## 2023-2031 Housing Element Implementation Project

### Final Environmental Impact Report State Clearinghouse No. 2022020362

**January 2024**

Figure 4.6-3 Piedmont Liquefaction Susceptibility on Page 4.6-7 has been replaced with the following:

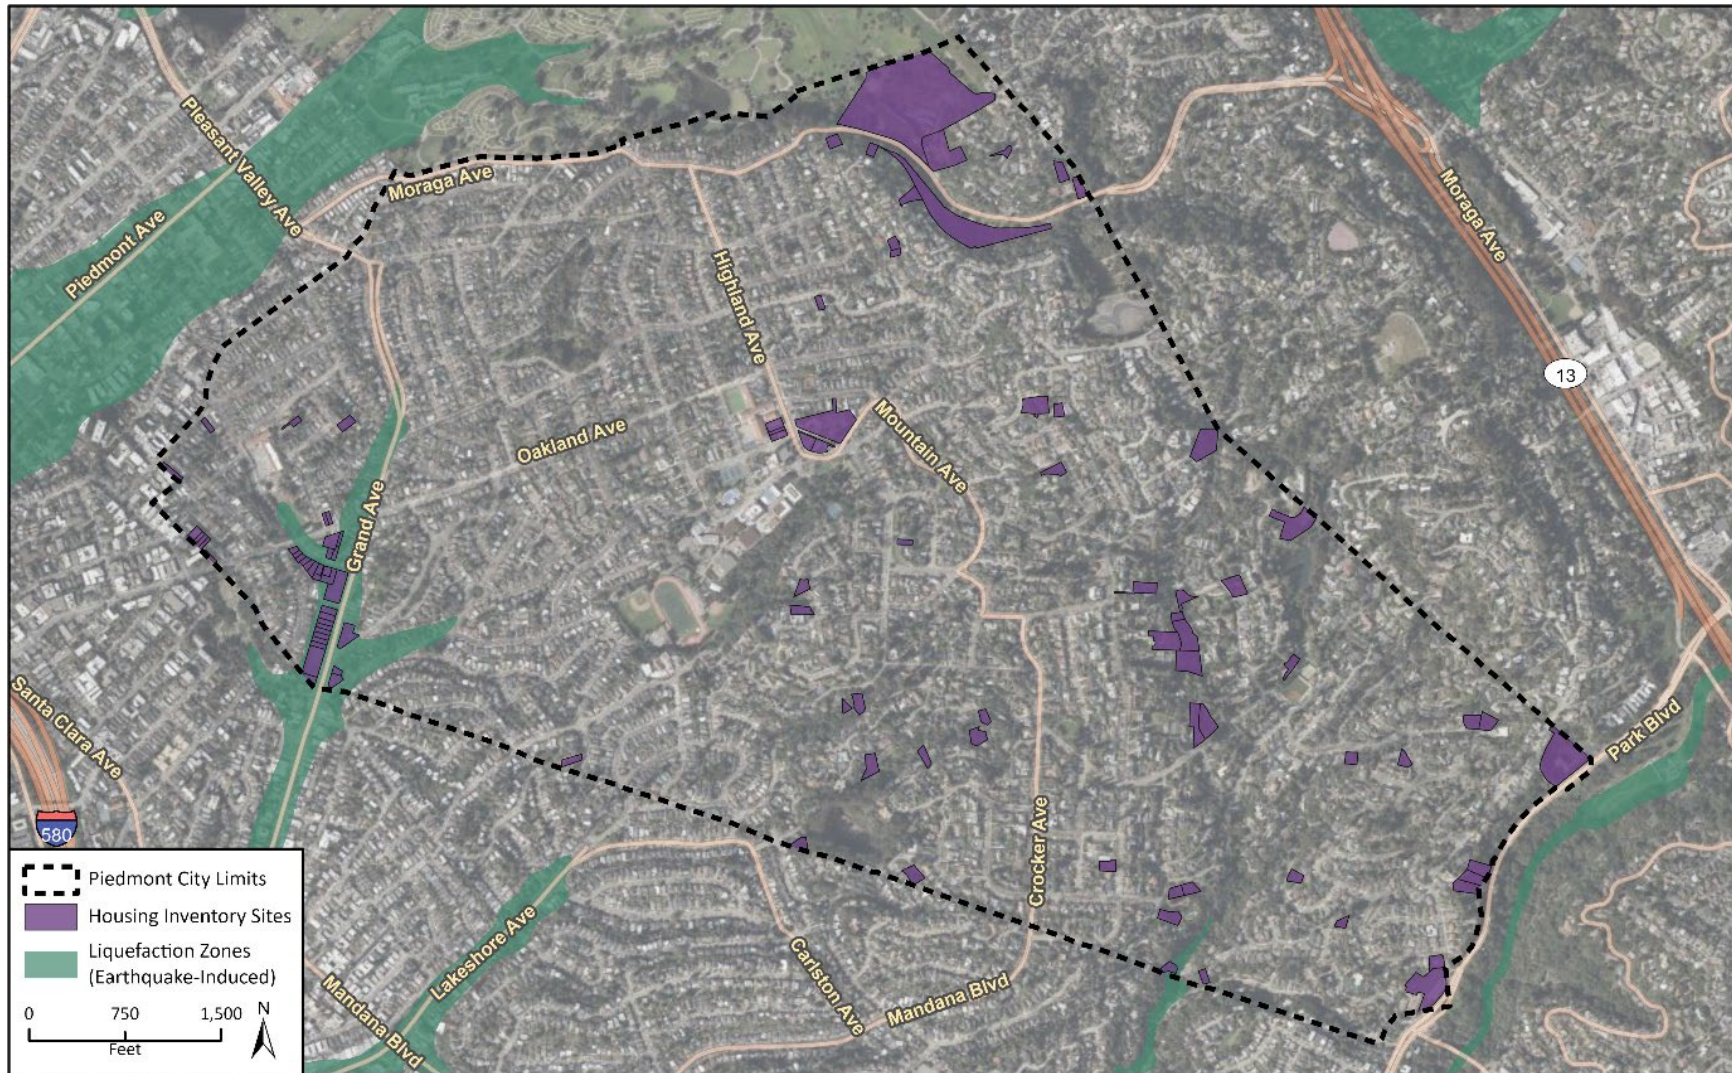
1. Liquefaction and Landslide Hazards
  - The Draft EIR discusses liquefaction and landsliding as potential hazards and provides a map of "Liquefaction Susceptibility" and "Landslide Susceptibility" based on the ABAG Hazard Viewer Map (Figures 4.6-3 and 4.6-4). CGS notes the landslide susceptibility zones depicted in Figure 4.6-4 represent "rainfall-induced" landsliding, not "earthquake-induced" landsliding, which is a unique triggering mechanism. The City should consider providing an additional discussion of this specific seismic slope instability hazard.

The commenter states that figures 4.6-3 and 4.6-4 of the Draft EIR are based on the ABAG Hazard Viewer Map. The commenter states the landslide susceptibility zones depicted in Figure 4.6-4 represent rainfall-induced landsliding and not earthquake-induced landsliding, which is a unique triggering mechanism. The commenter suggests that the City should provide additional discussion of the specific seismic slope instability hazard.

As discussed under the Geologic Hazards Setting in Section 4.6, *Geology and Soils*, Figure 4.6-3 is based on the ABAG Hazard Viewer Map, while Figure 4.6-4 is based on the California Department of Conservation MS58 Deep-Seated Landslide Susceptibility Map, which shows the relative likelihood of deep-seated landsliding based on regional estimates of rock strength and steepness of slopes, and not rainfall-induced landsliding. Nonetheless, as discussed in Response 3.2, Figures 4.6-3 and 4.6-4 of the Draft EIR and the discussion regarding these figures have been updated to reflect CGS data and maps. These revisions do not affect the findings or conclusions of the Draft EIR.

As shown in Figure 4.6-3, Piedmont is generally not located in areas of ~~very low or low~~ earthquake-induced liquefaction risk, except for a small portion of the city along Grand Avenue and Fairview Avenue and north of Valant Place, as well as small portion of the city southeast of the intersection at Grand Avenue and Oakland Avenue which is located in an area with high liquefaction risk and areas with uncompacted fill such as in Moraga Canyon. Several housing sites are located within the liquefaction zone along Grand Avenue, and one housing site is located within the liquefaction zone north of Valant Place. ~~Three housing inventory sites are located adjacent to the high liquefaction zone east of Grand Avenue and one is within Moraga Canyon.~~ Full build-out of the proposed project would increase population, structural development, and infrastructure that would be exposed to these hazards.
